## APPROVED DOCUMENT CHANGE CONTROL FORM

DOE-RL, Rev. 1, "Remedial Investigation/ Feasibility Study Work Plan for the

200-BP-1 Operable Unit, Hanford Site,

Richland, Washington

200-BP-1 Operable Unit Surface Sampling Locations

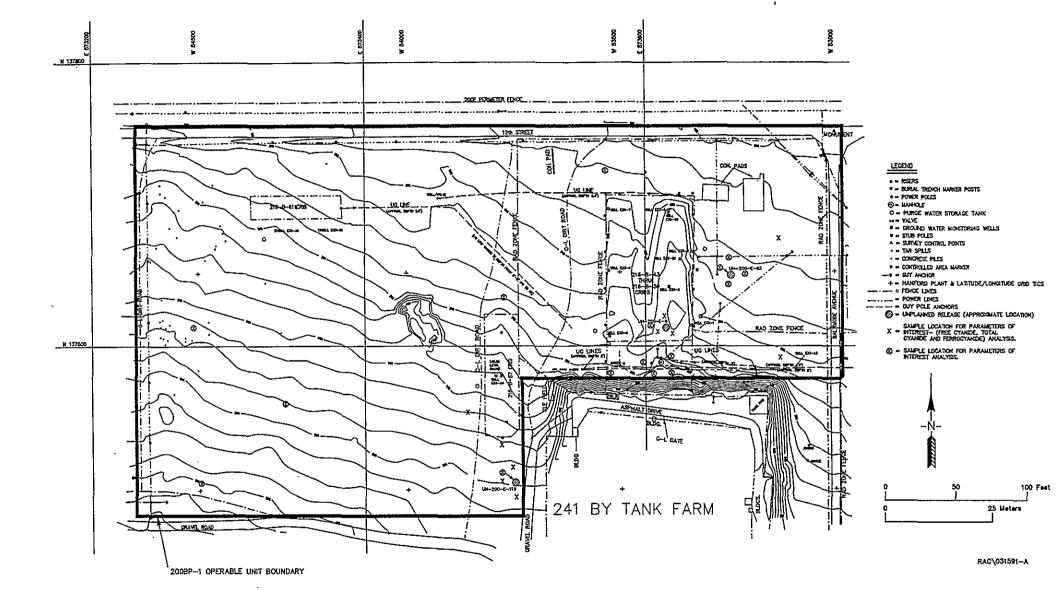
Change the 1st sentence on WP-140, Section 5.1.3.4 to the following: samples will be sampled at locations shown in Figure 31A. Additional samples, if required, will be collected based on the results of the initial data."

Change the 2nd sentence on WP-143, Section 5.1.3.4 to the following: "Soil samples will be sent to a qualified laboratory for analysis of parameters of interest with selected reduction of cyanide analysis as illustrated on Figure 31A."

Insert Figure 31A in WP.

Change the 1st sentence of the 1st full paragraph on SAP/FSP-19, Section 2.3.7 to the following: "Soil samples will be sent to a qualified laboratory for analysis of parameters of interest with selected reduction of cyanide analysis as illustrated on Figure 4A."

Insert Figure 4A in SAP/FSP.

In order to perform interim surface stabilization within the 200-BP-1 operable unit, near surface soil sample will be collected prior to initiating field activities. Sampling locations are based on unplanned spills, flush tank, selected "hot spots" identified by scintillation and background samples. Additional soil samples, if required, will be collected based on the results of the initial data.
